From: Carla DiCandia <Carla.DiCandia@stjoe.org>
Sent: Monday, February 23, 2015 9:30 AM
To: SOCRE CEQA
Subject: Re: Notice of Availability South Orange County Reliability Enhancement Project Draft Environmental Impact Report

NOTICE OF AVAILABILITY
SAN DIEGO GAS AND ELECTRIC COMPANY
SOUTH ORANGE COUNTY RELIABILITY ENHANCEMENT PROJECT
DRAFT ENVIRONMENTAL IMPACT REPORT

Figure 1:
SOCRE Project
Design Revisions

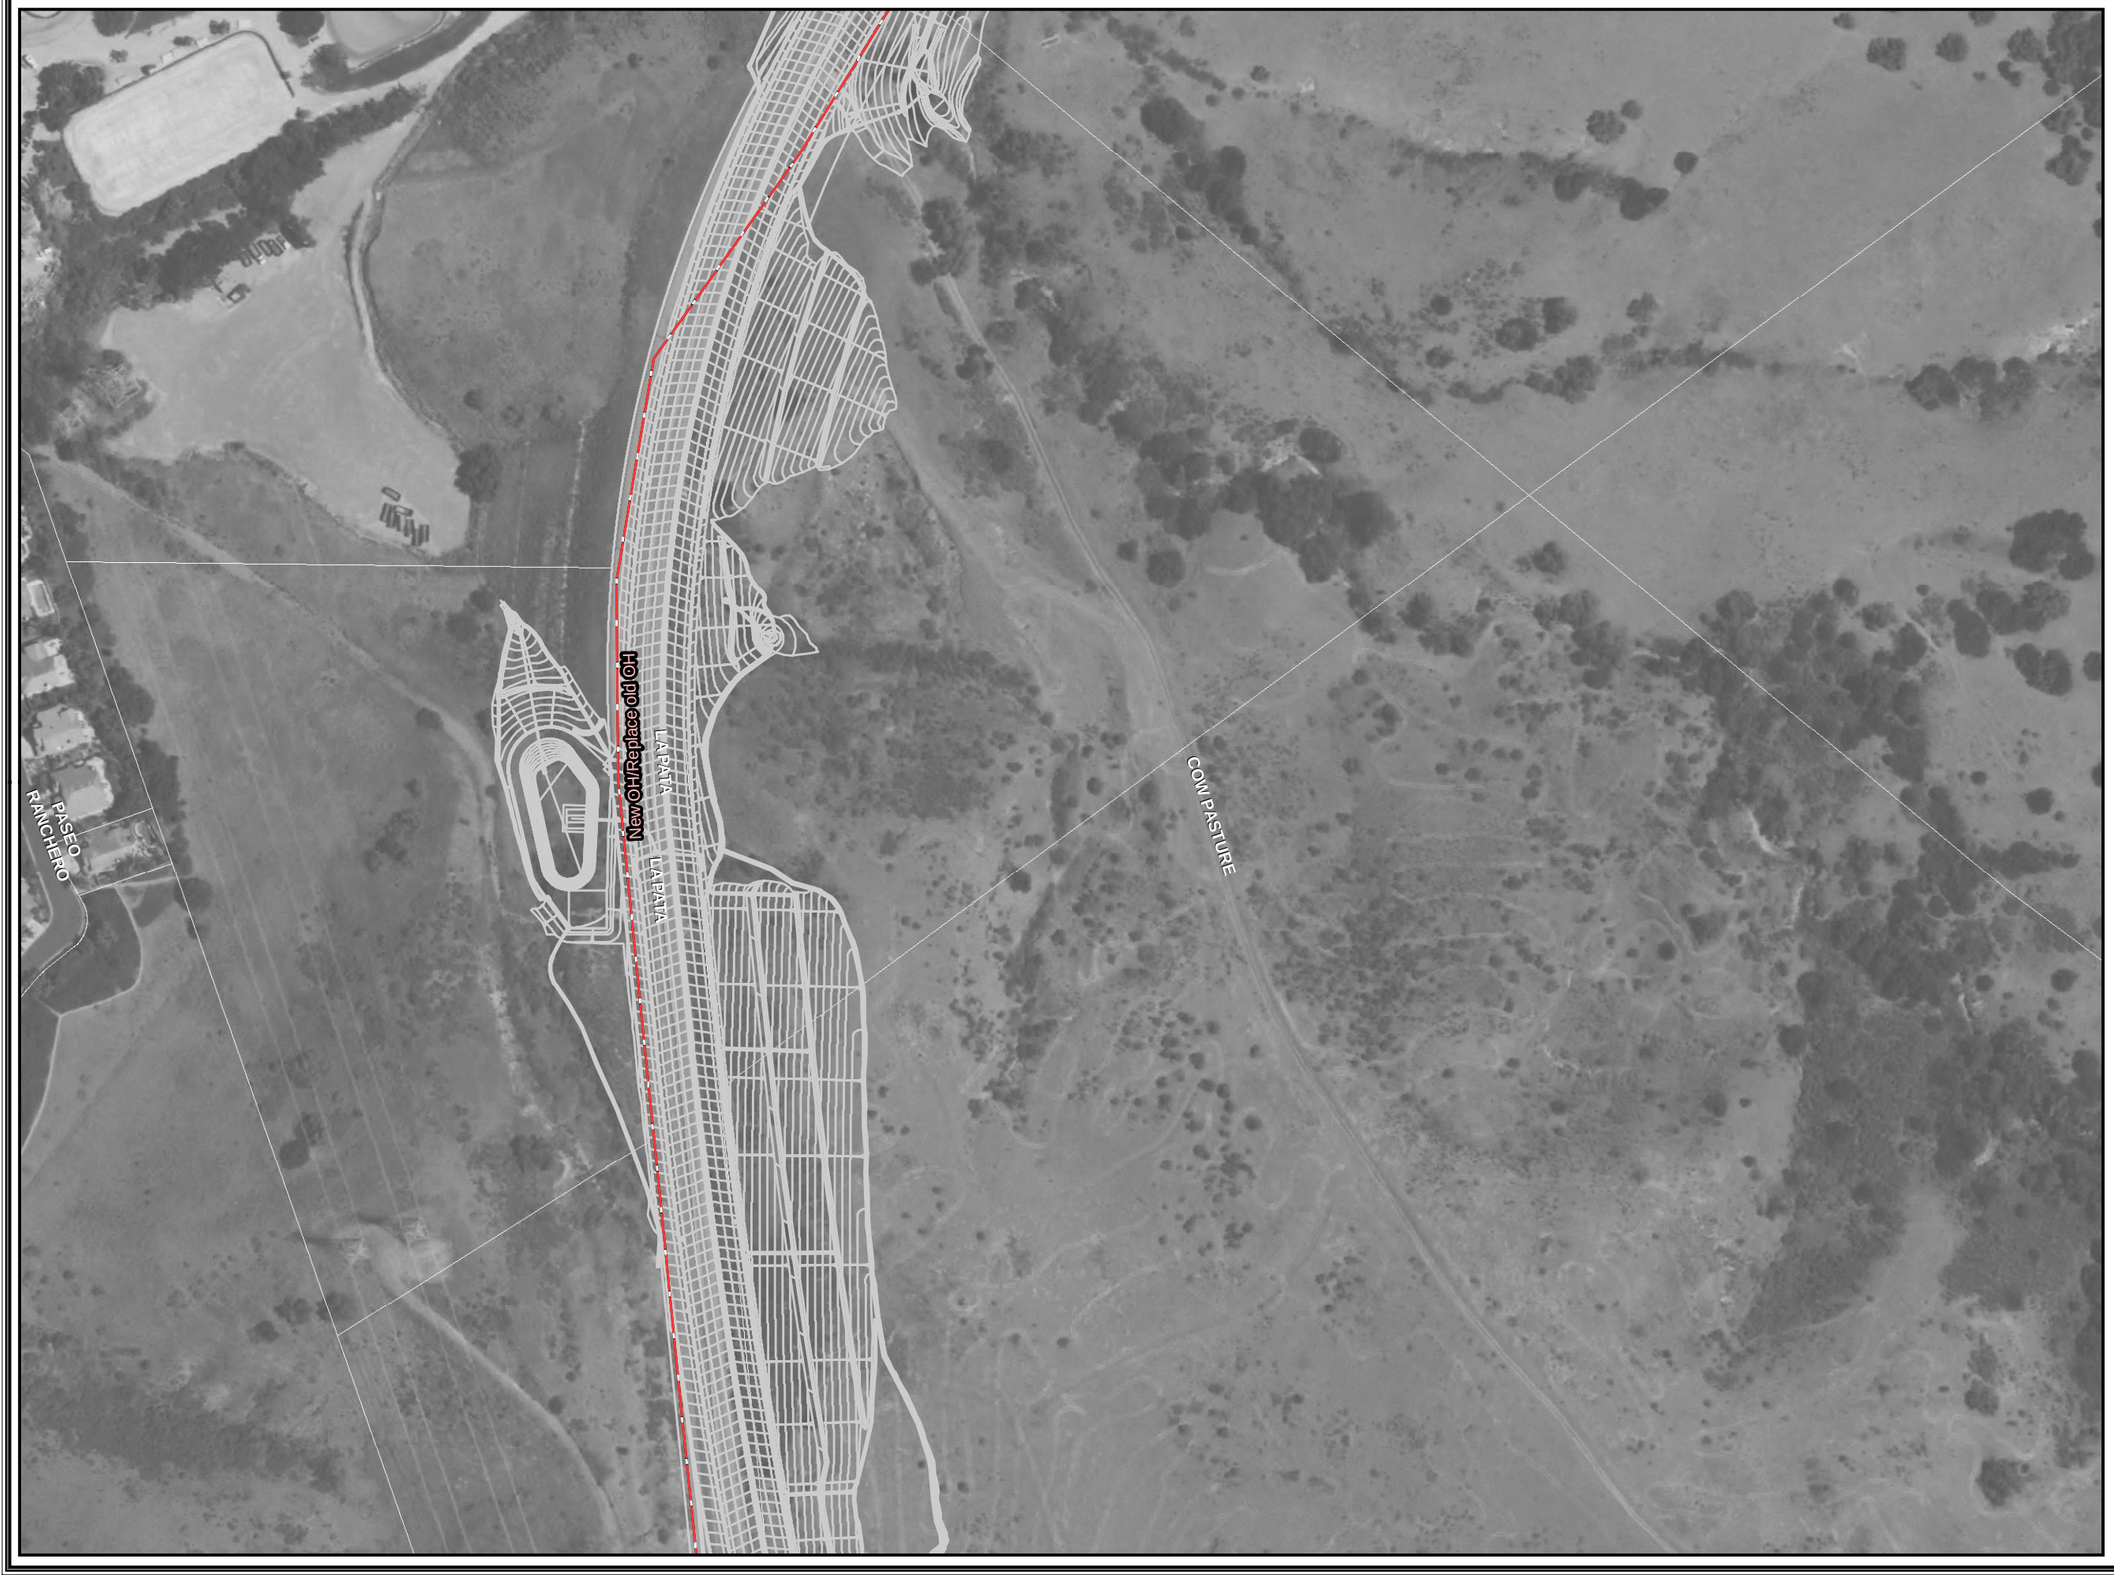
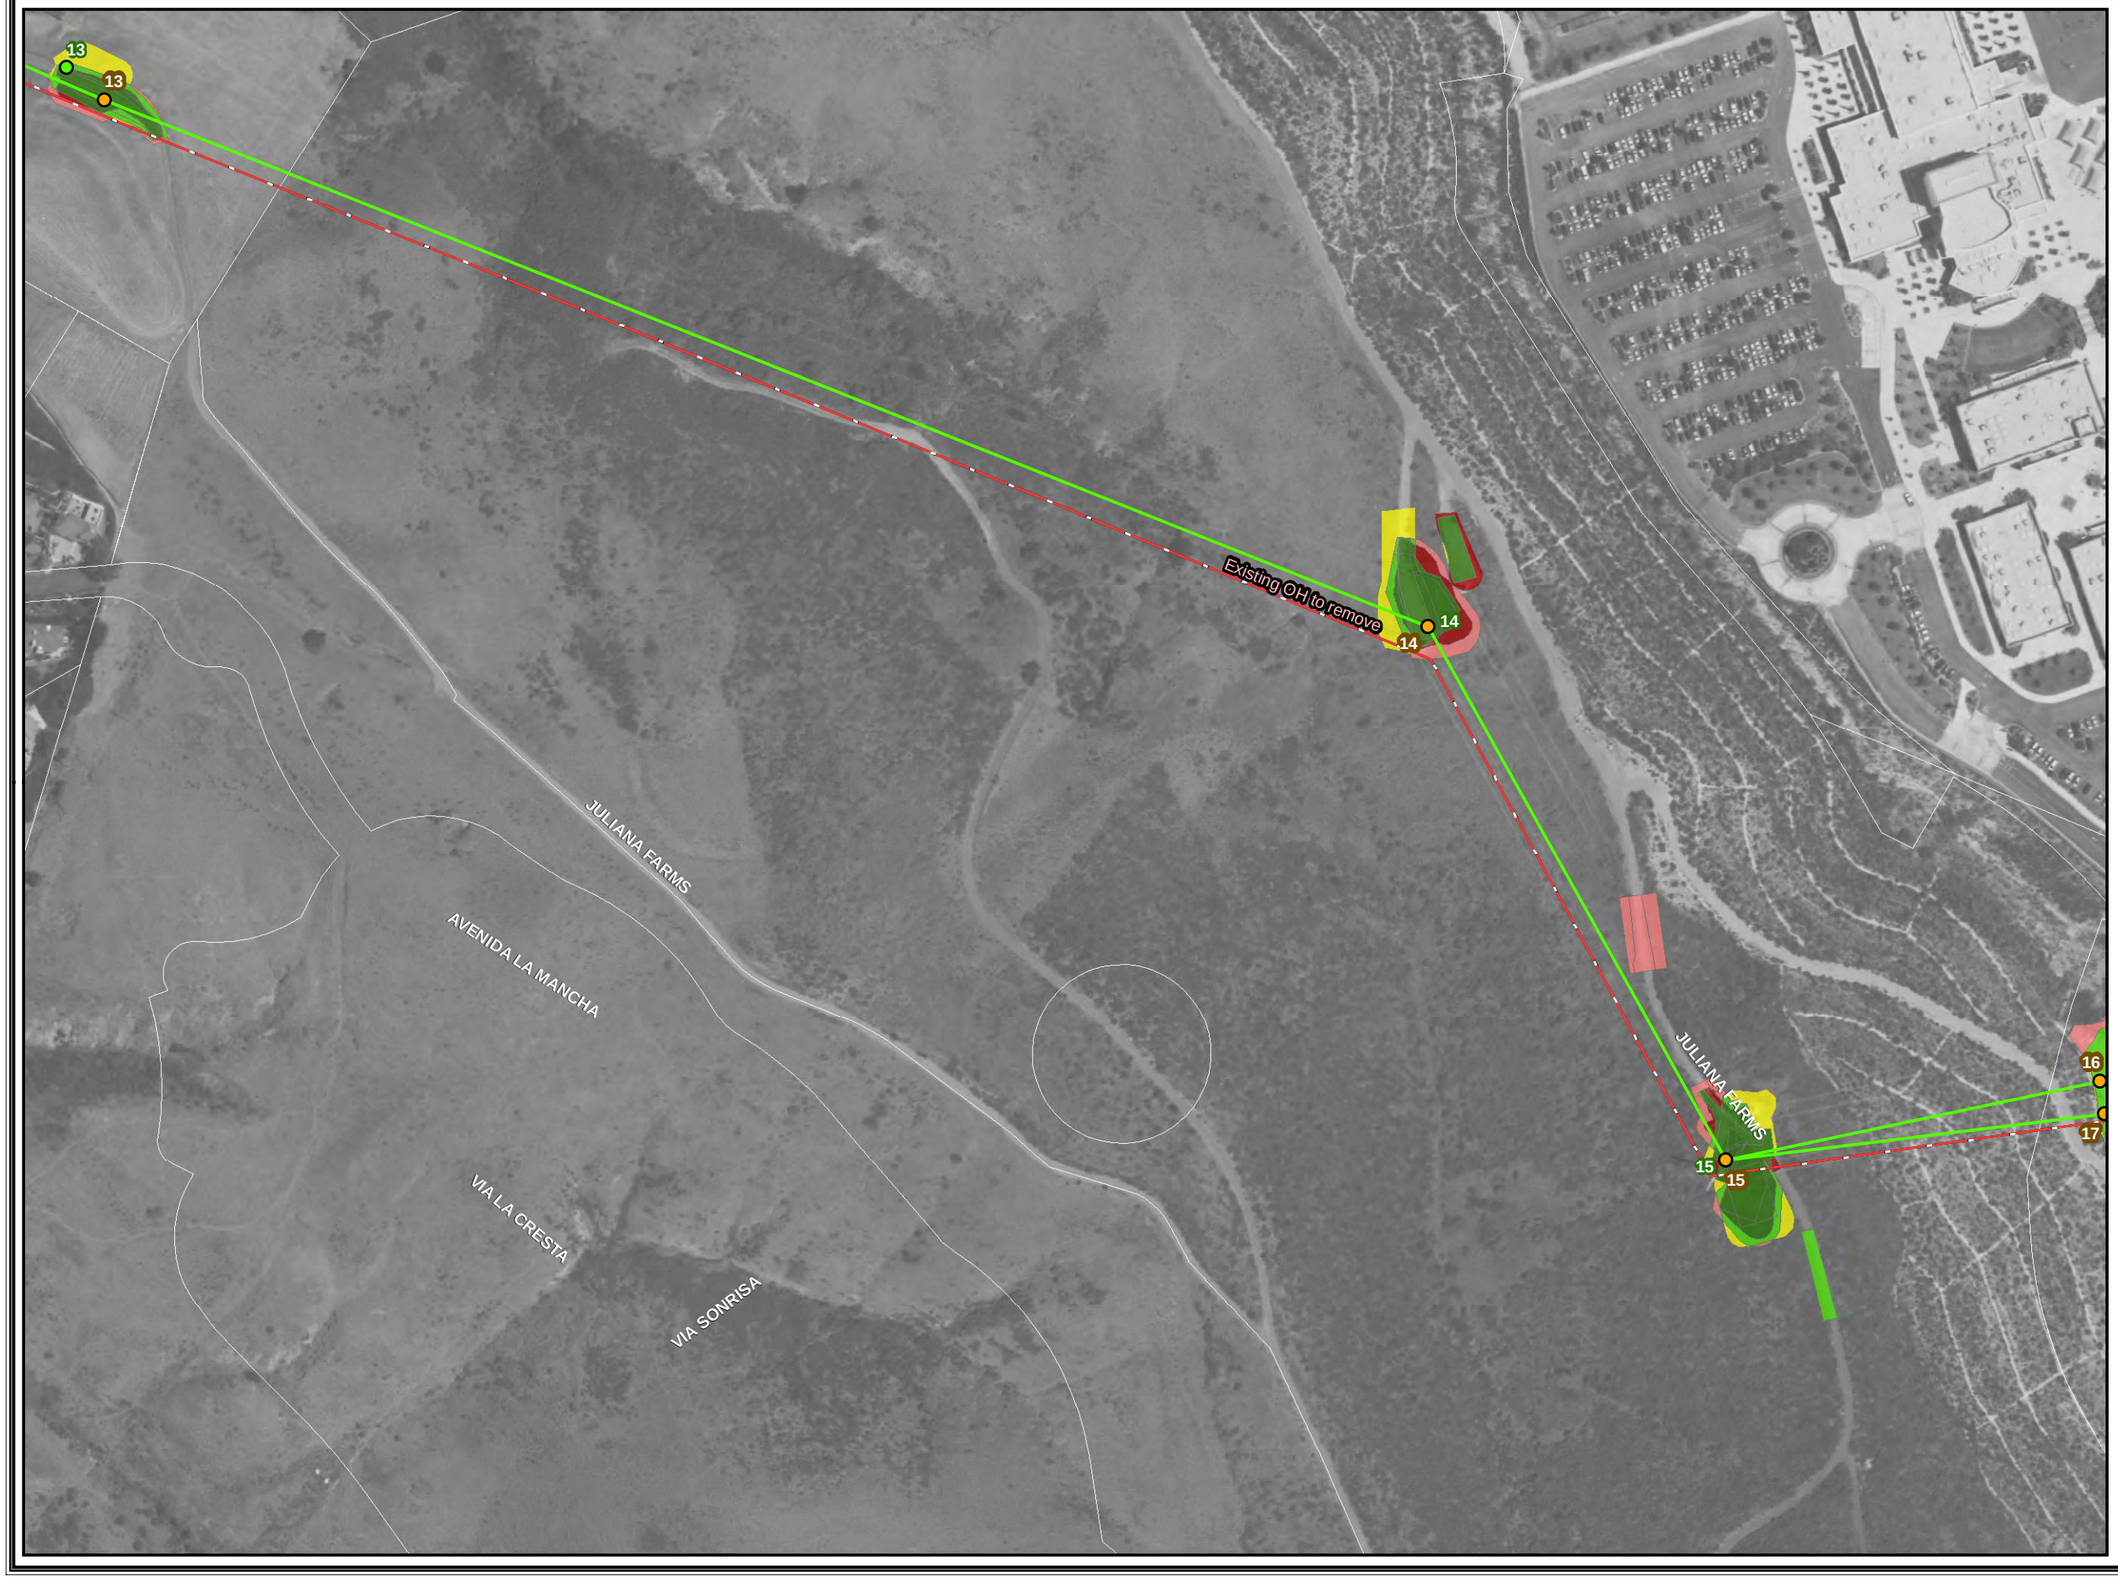
Proposed 138kV cable poles 1a and 2a have been shifted approximately 200 feet east to ensure constructability and avoid additional work within the 138kV system. This reduced the length of the proposed 138kV underground by approximately 420 feet (refer to Figure 1). Other minor structure relocations were made along Segment 1a to ensure constructability. All relocated structures on Segment 1a remain in existing SDG&E right-of-way (refer to Figure 1 and Exhibit 2).

The 138kV and 12kV Jack-and-Bore increased in length from approximately 130 feet to approximately 275 feet. SDG&E increased the length of the jack and bore distance in order to relocate the construction work further away from the nearby residences and to allow for proper construction clearances. The boring now ends west of Calle San Diego (refer to Figure 1).

230kV structures 1, 2, and 3 were shifted based on refined engineering for the 230kV transmission line entrance into the San Juan Capistrano Substation (refer to Figure 1). The remaining structures were shifted slightly along the alignment to ensure constructability of foundations and grading. All relocated structures on Segment 1b remain in existing SDG&E right-of-way.

Proposed 138kV cable pole 8a has been removed from the Proposed Project based on revised 230kV underground design which no longer requires the relocation of this structure (refer to Exhibit 2 and Figure 1).

A new communication cable pole has been added north of Talega Substation to accommodate communication requirements (refer to Figure 1). A new distribution pole replacement was added to account for anticipated structure loading on the existing structure. The replacement distribution structure is located south of the Talega Hub, between Structures 1b and 2b.

SDG&E is proposing to move the 12kV distribution lines to an existing access road located along the southern border of Junipero Serra Park (refer to Figure 1, page 2). This will eliminate extensive grading and tree removal to accommodate the relocation of the 12kV distribution lines on 12kV Segment B to the northern portion of the park, where SDG&E has existing underground ROW. Construction of the 12kV distribution lines in the southern border location (existing paved access road) would reduce the adverse impacts associated with distribution line Segment B. SDG&E will work with the City of San Juan Capistrano to obtain underground rights along the existing paved access road along the southern border of Junipero Serra Park.
